SUBJECT: O'FALLON COMMUNITY PARK ENHANCEMENTS
NEW POOL AND AMPHITHEATER (PHASE 1)
411 EAST 5TH STREET
O'FALLON, IL 62269

FGM Project No.: 23-3773.01

This Addendum forms a part of the Bidding and Contract Documents and modifies the original bidding documents dated February 14, 2024, and project Addendum #1 documents dated February 26, 2024. Acknowledge receipt of this Addendum in space provided on Bid Form. **Failure to acknowledge addenda may subject bidders to disqualification.**

Code Compliance Plan SHEET NO. G1.1. Includes project number (JOB NO. 23-3773.01) and date (© 2024 FGM Architects Inc.).

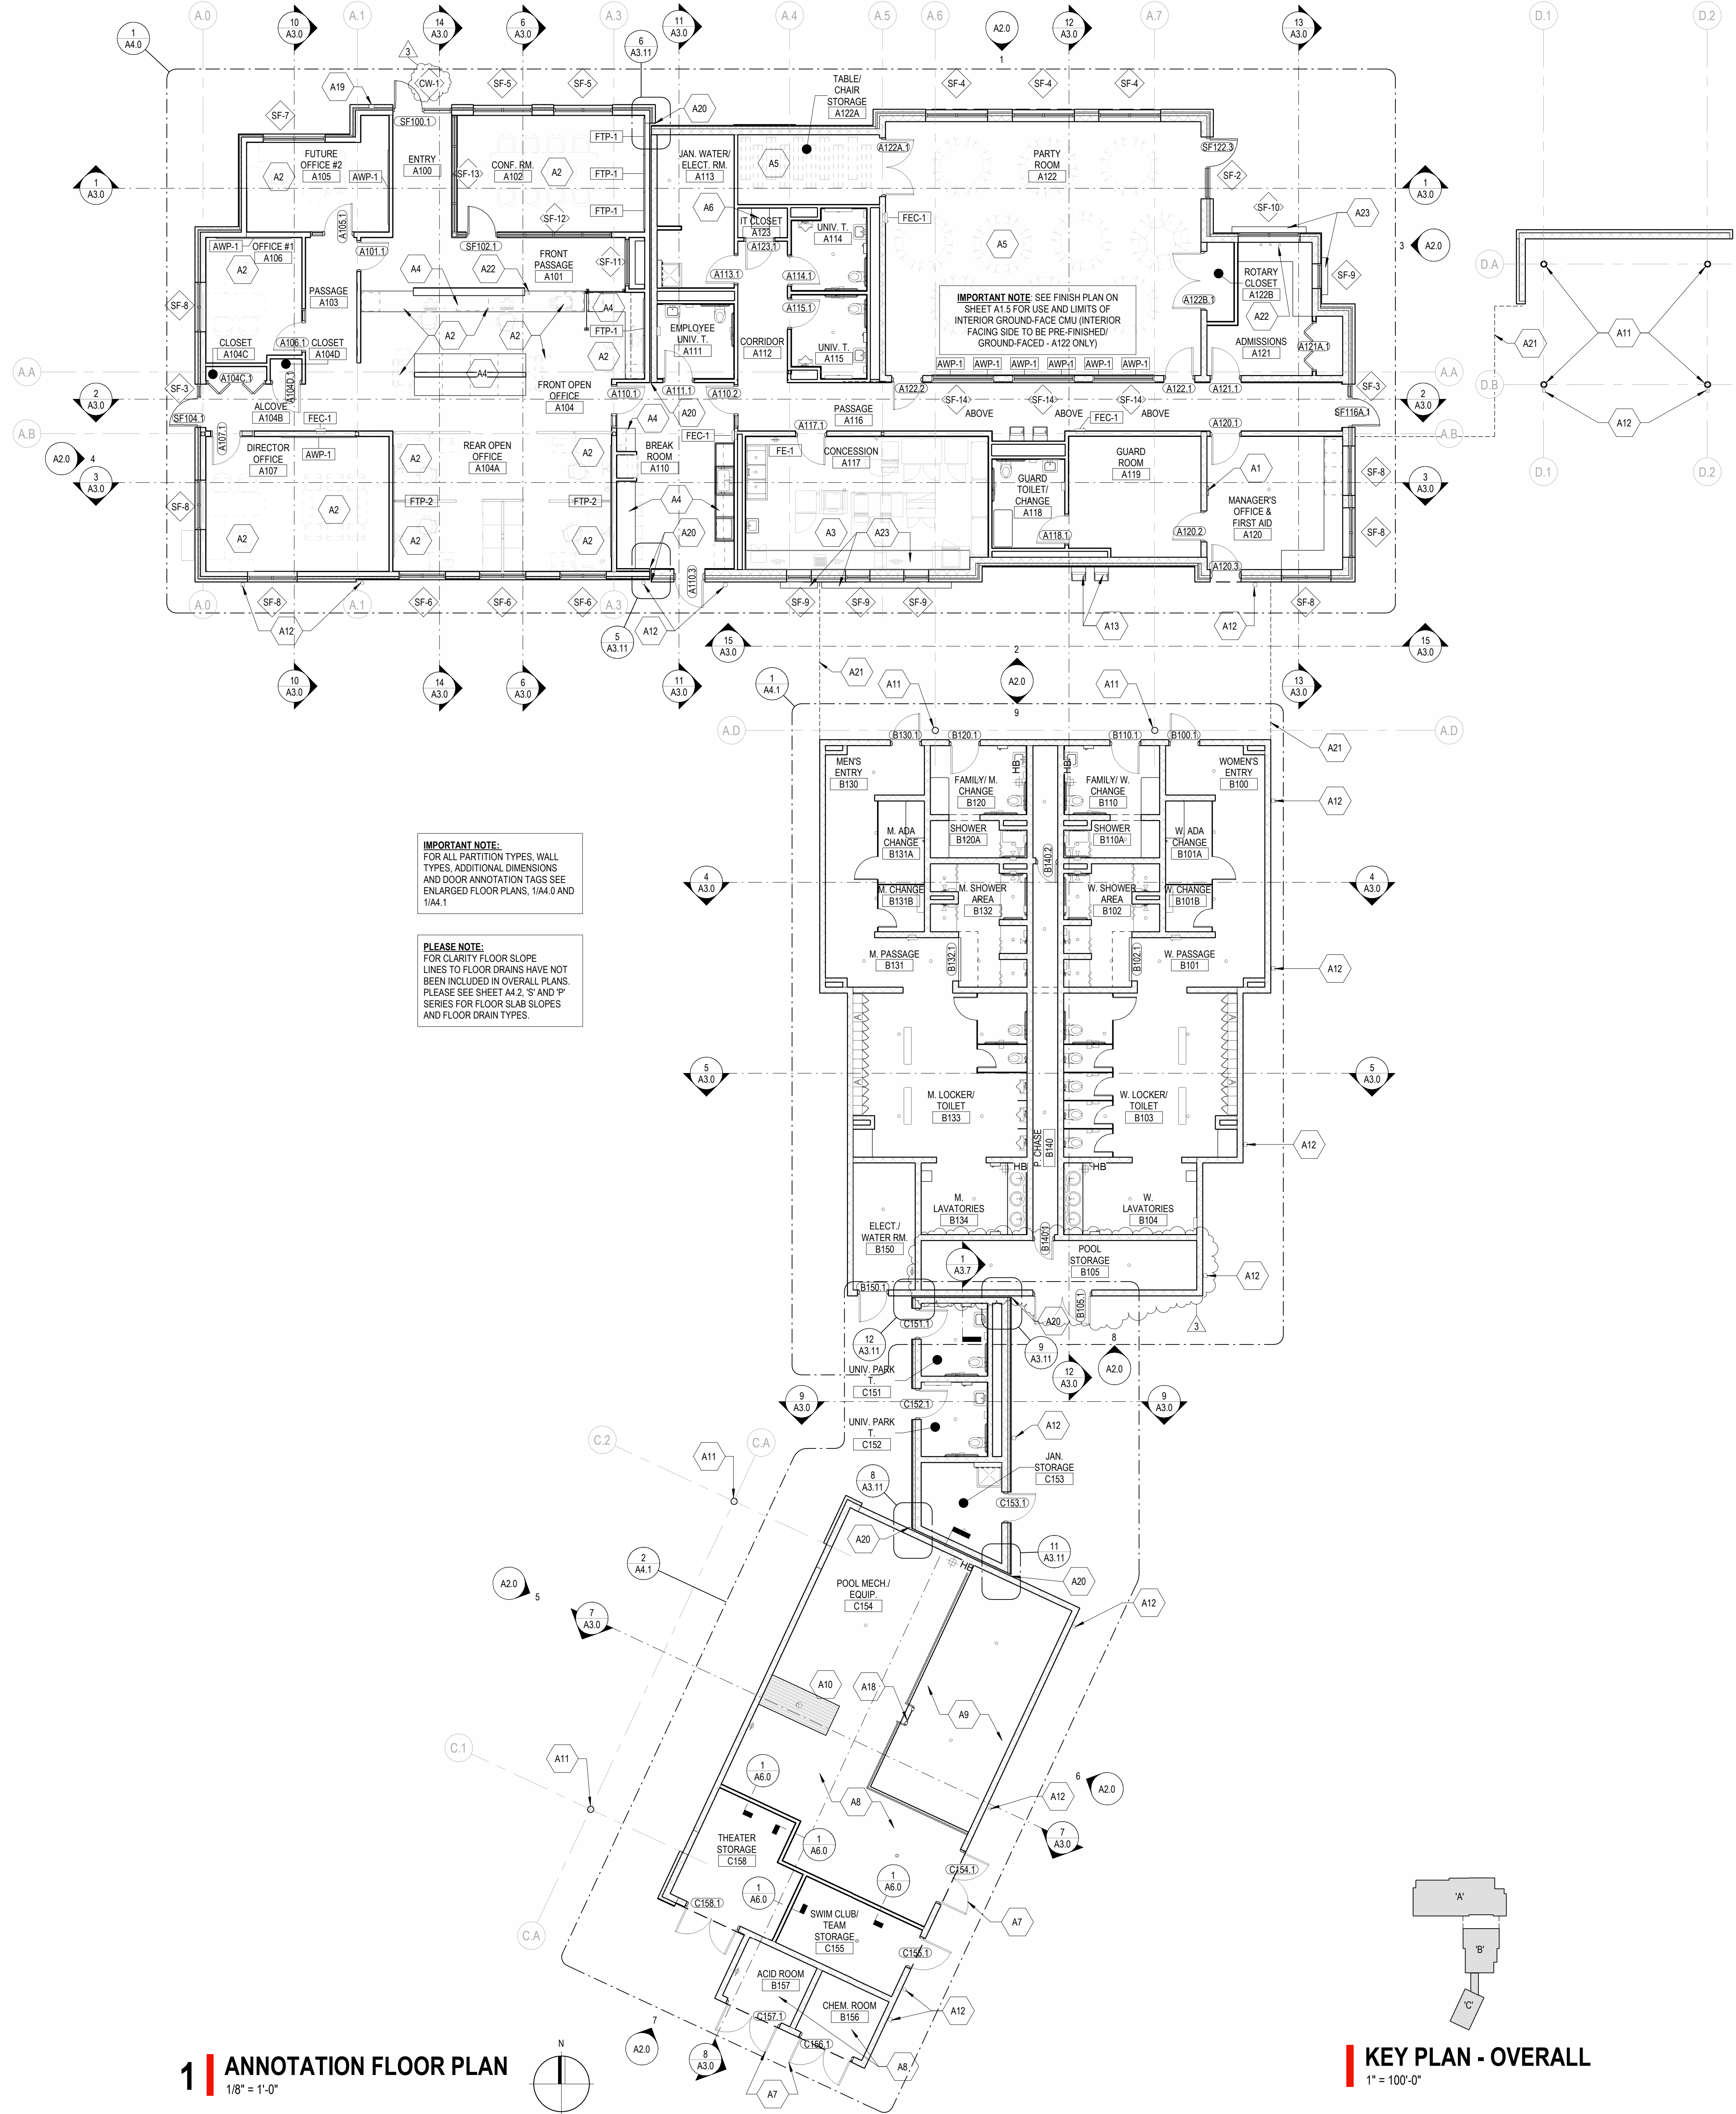
2. SHEET G1.1 – Code Compliance Plan (Sheet Reissued)
 - A. 1 Code Compliance Plan, **REVISE** Building B paths of travel and door calculations for doors B130.1 and B100.1 **as SHOWN** in attached Drawing. Revisions resulting from elimination of South Egress Exit and Doors out of Rooms B133 and B103 Locker Room areas as described in Clarification #1.

DIMENSION FLOOR PLAN
SHEET NO.
A1.2
JOB NO. 23-3773.01
© 2024 FGM Architects Inc.

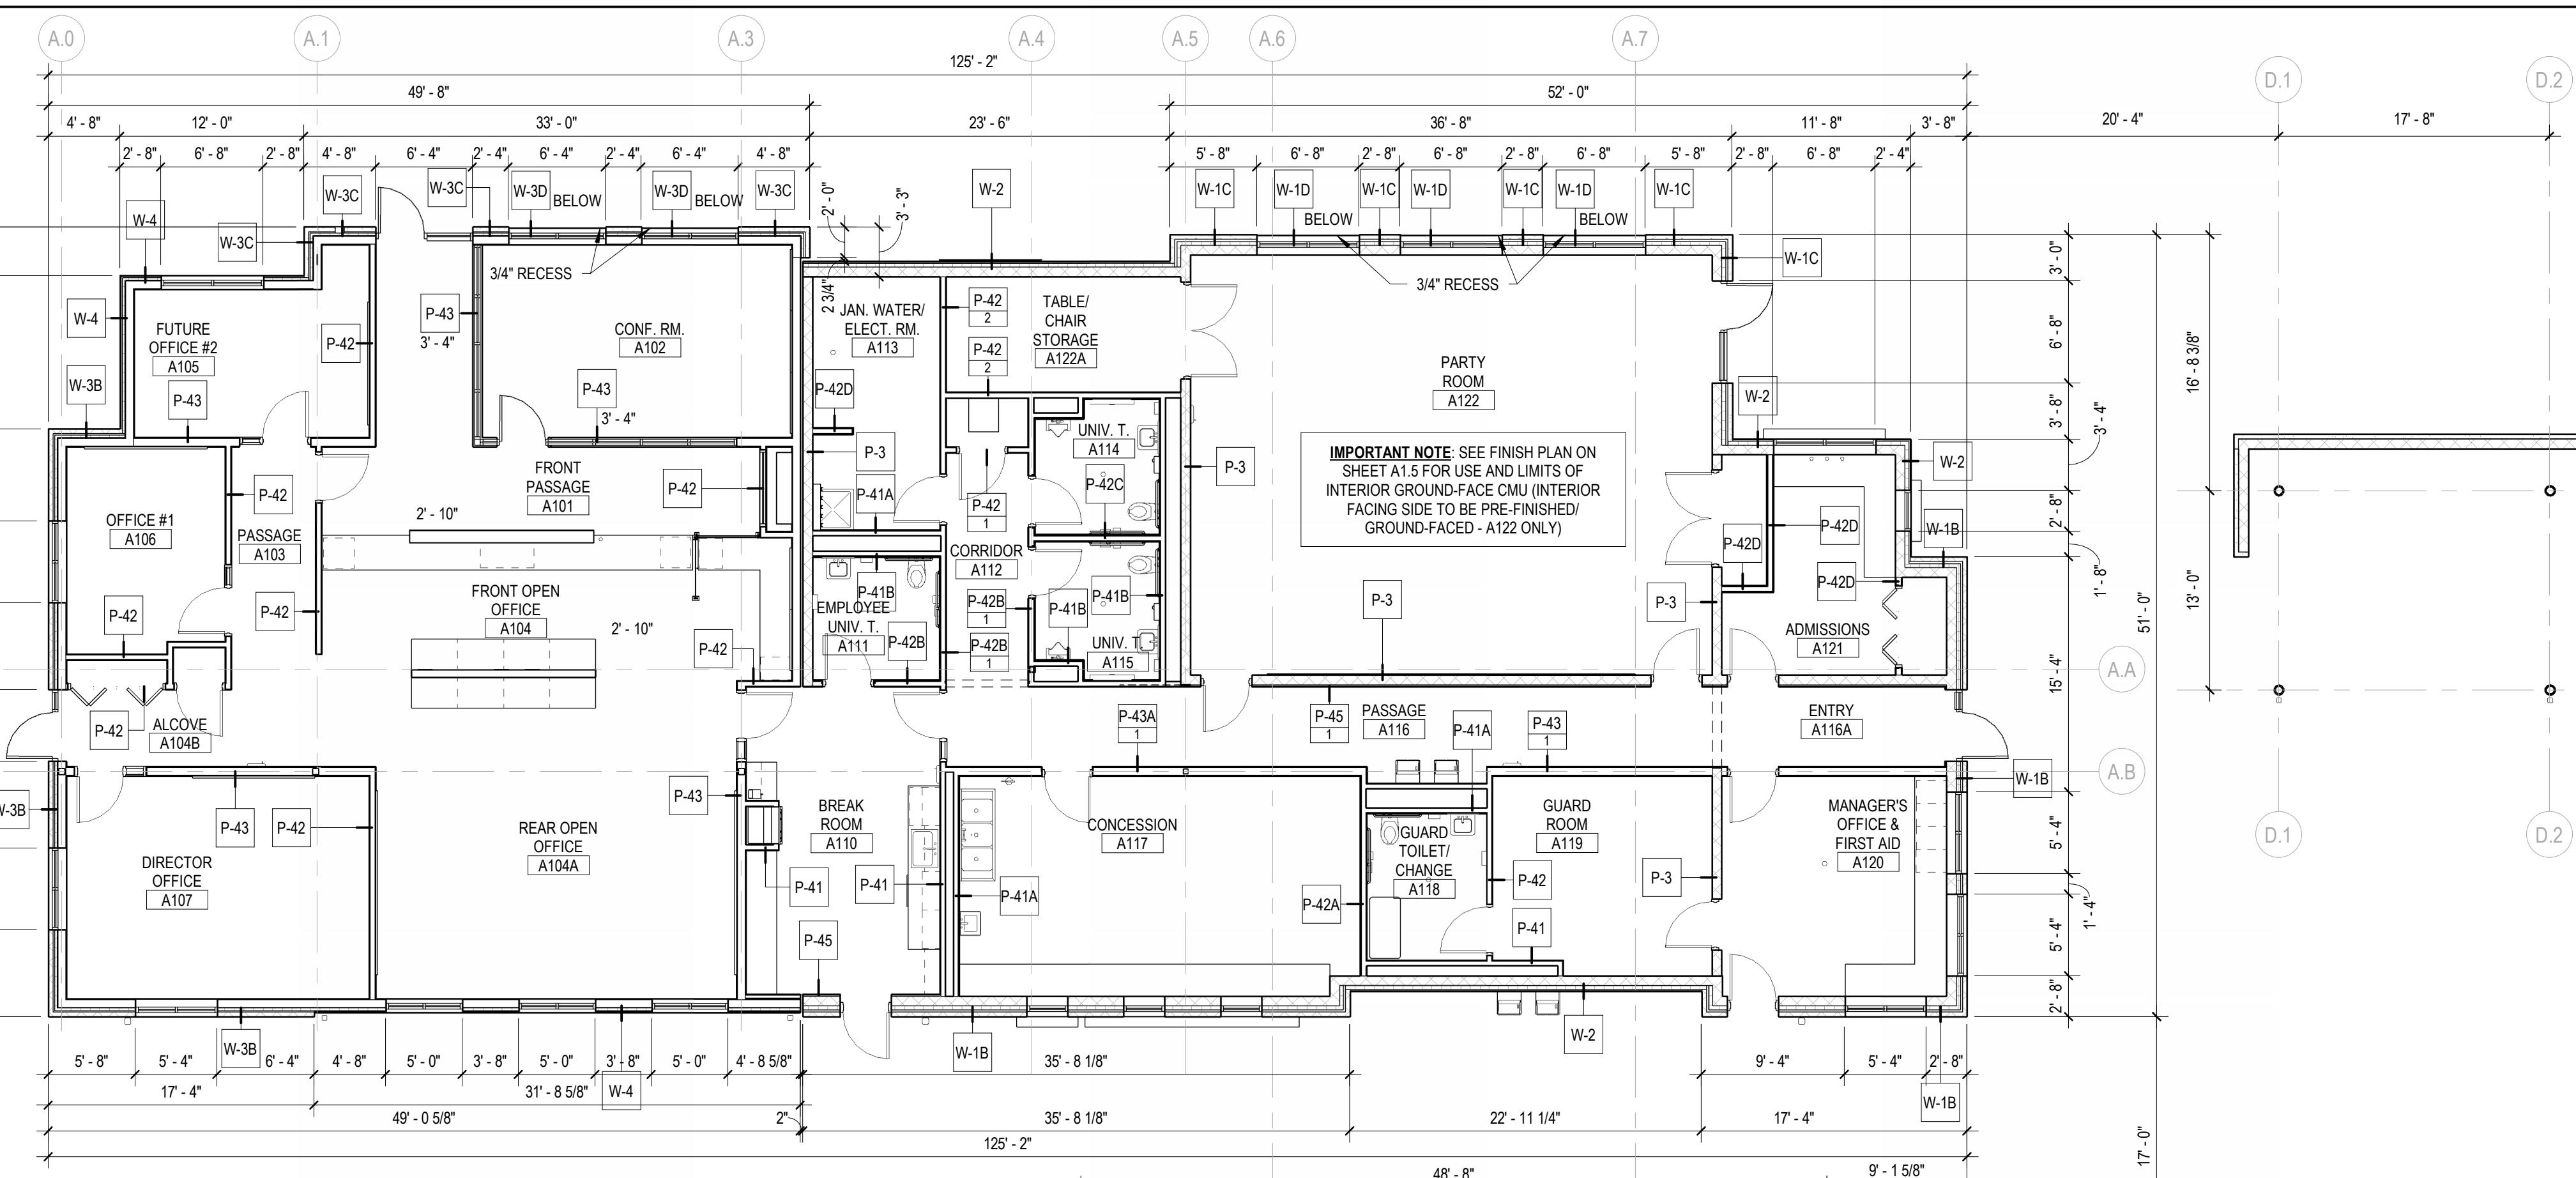
4. SHEET A1.2 – Dimension Floor Plan (Sheet Reissued)
 - A. 1 Dimension Floor Plan, **REVISIONS as SHOWN** to Room area B105 as described in Clarification #1, and **REVISE as SHOWN** dimension string Plan South of Building B.

4 | WALL SECTION
3/4" = 1'-0"

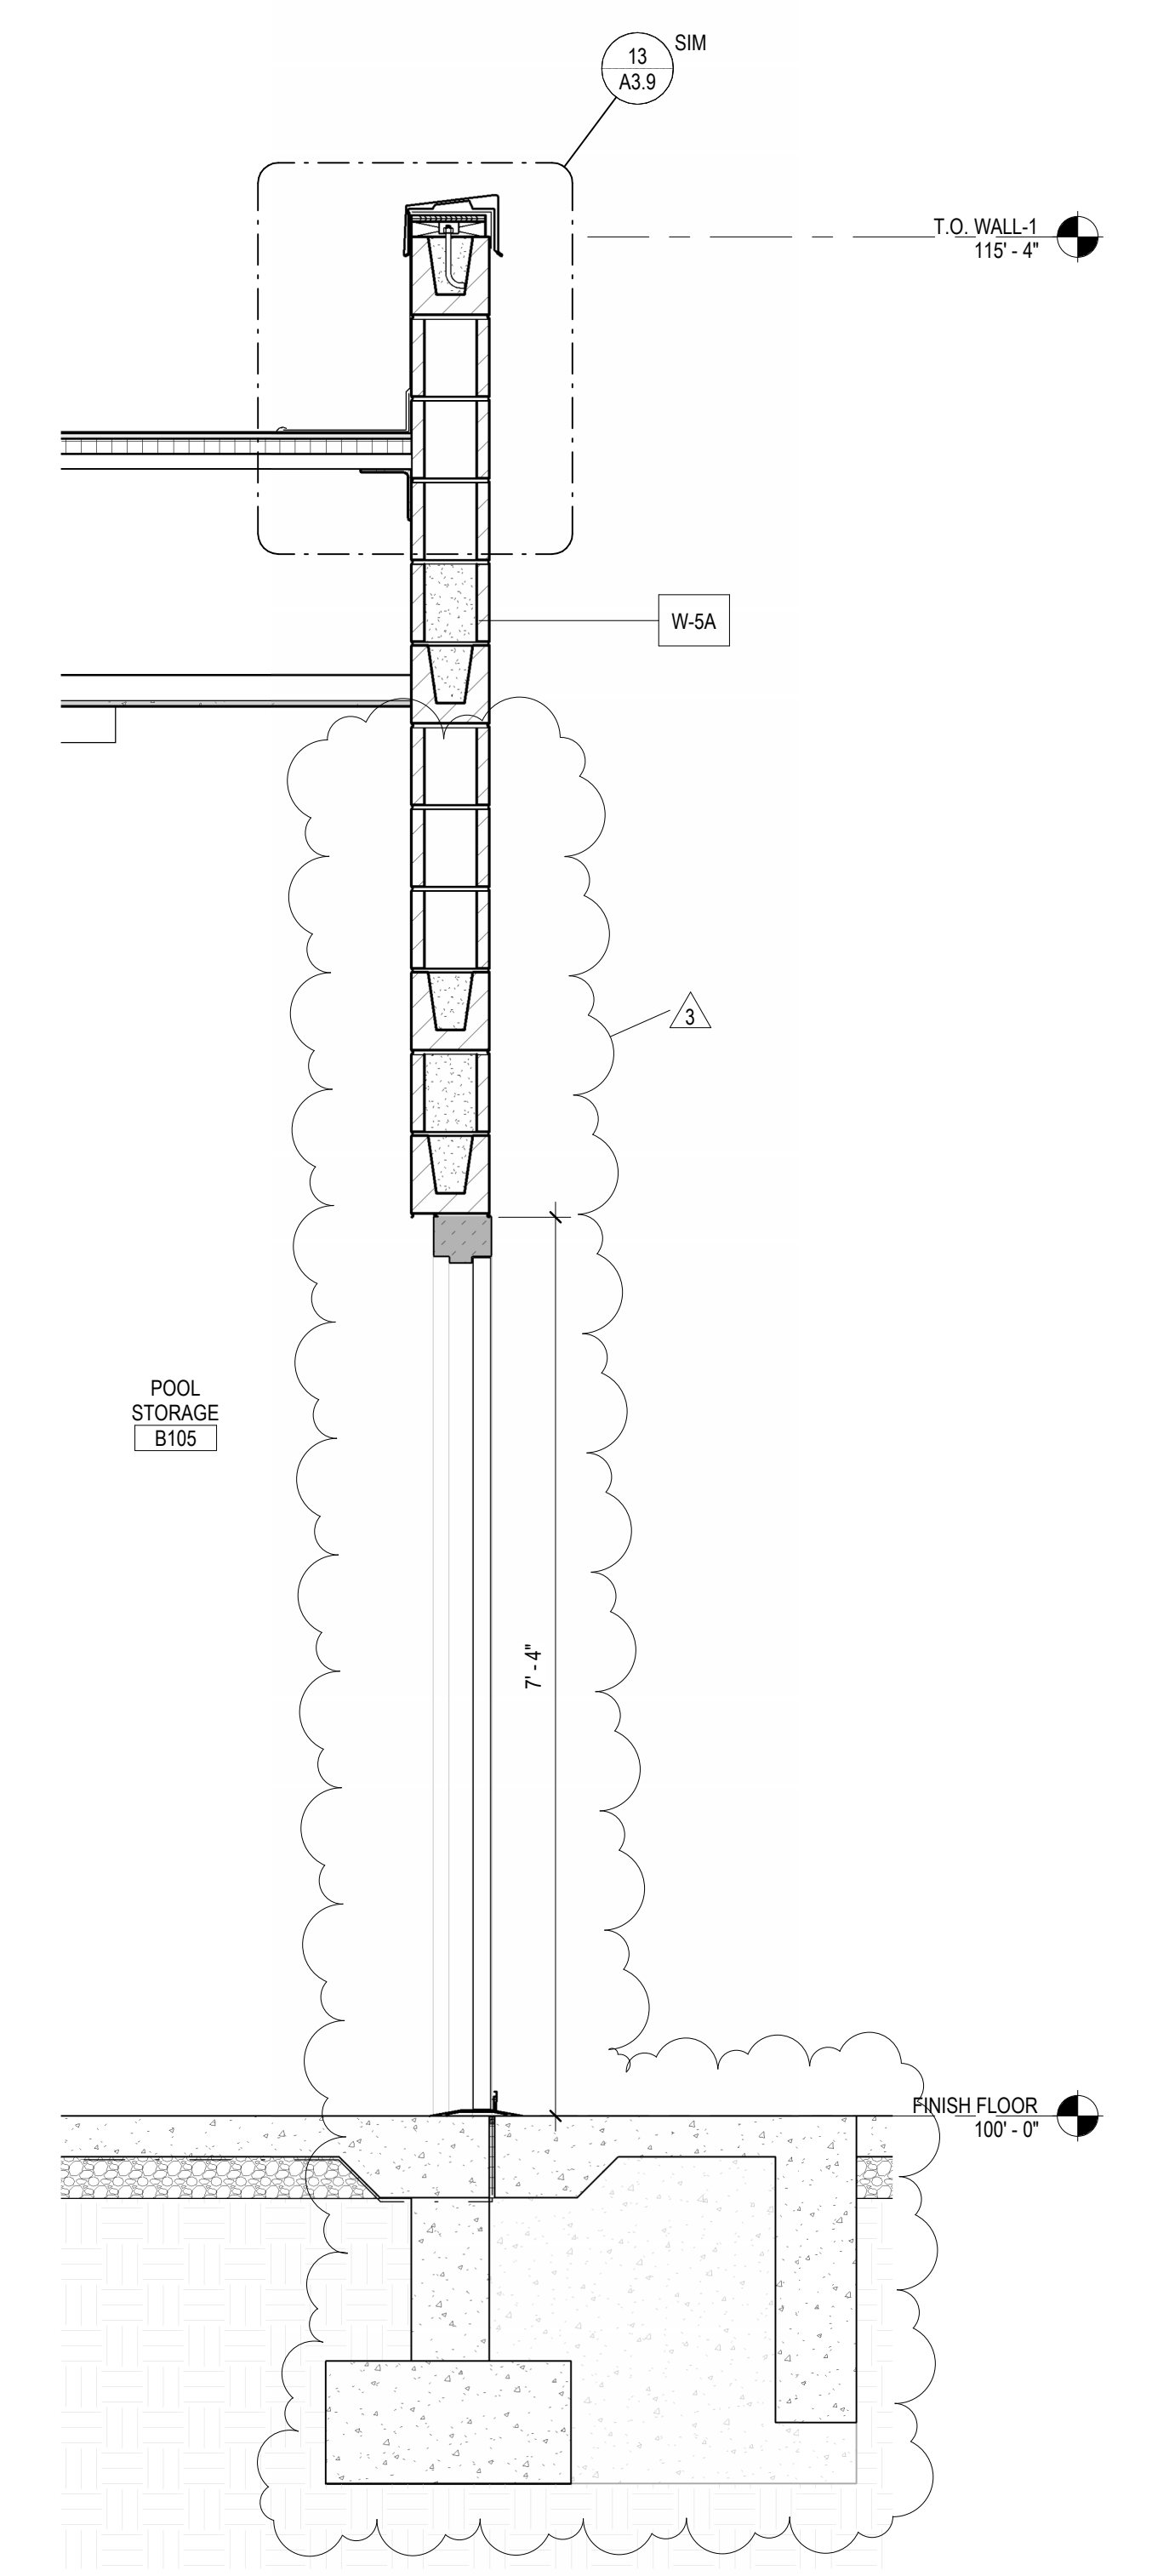
9. SHEET A3.6 – Wall Sections (Sheet Reissued)
- Detail 4 Wall Section, **REVISE as SHOWN** in attached Drawing. Thru-Wall louver is **DELETED** and wall section cut now through new Door B105.1 which is shown.

14 | WALL SECTION DETAIL
1 1/2" = 1'-0"

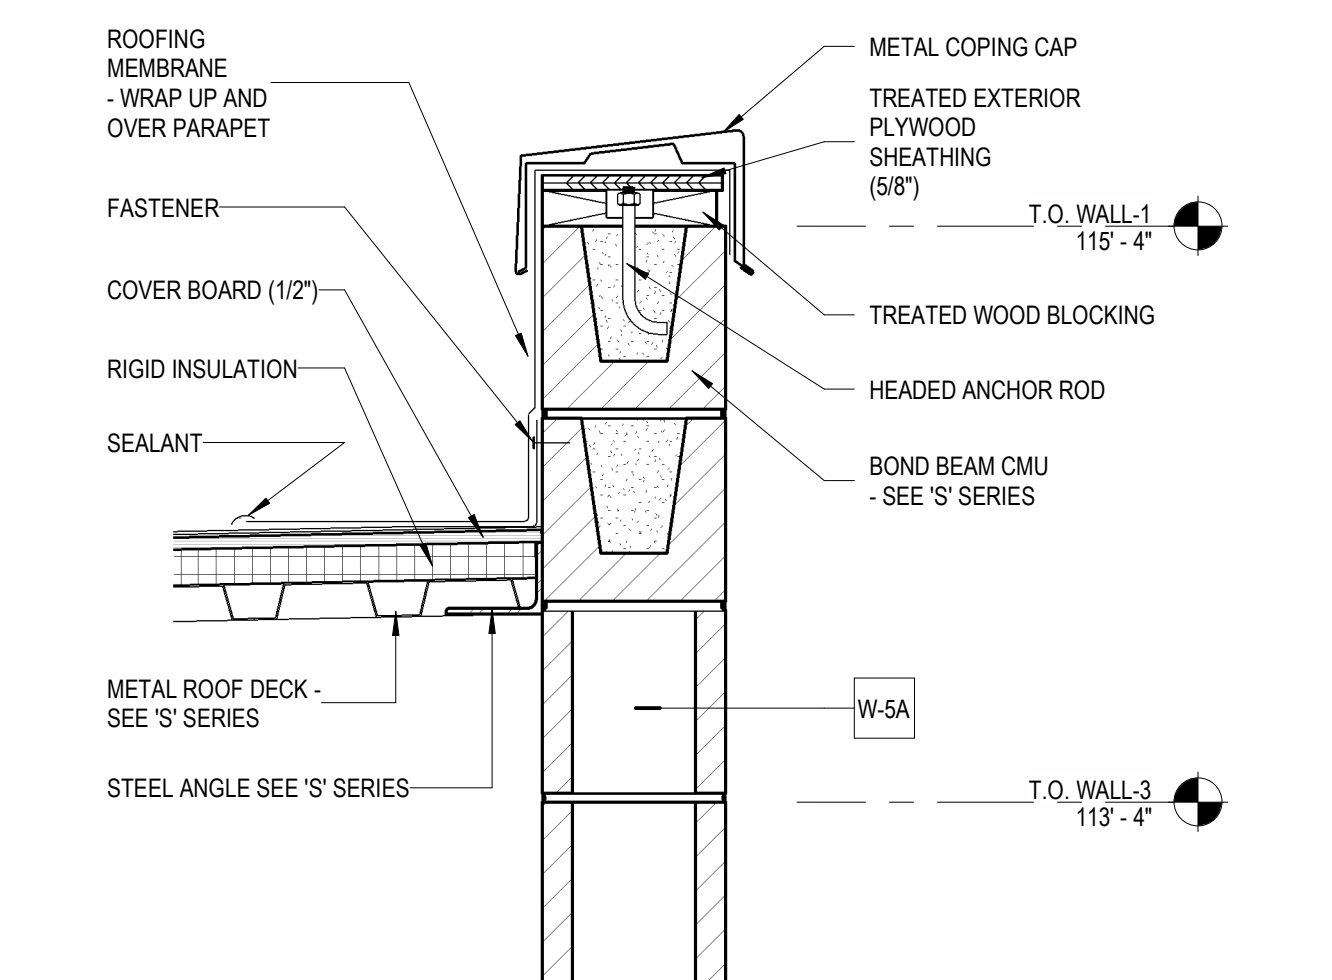
- Detail 14, **REVISE** sheathing product at rear (roof) side of parapet to Plywood **as SHOWN** in Attached Drawing and **REVISE** "Fiberglass-Faced Gypsum Sheathing" **to READ "Plywood Sheathing"**.
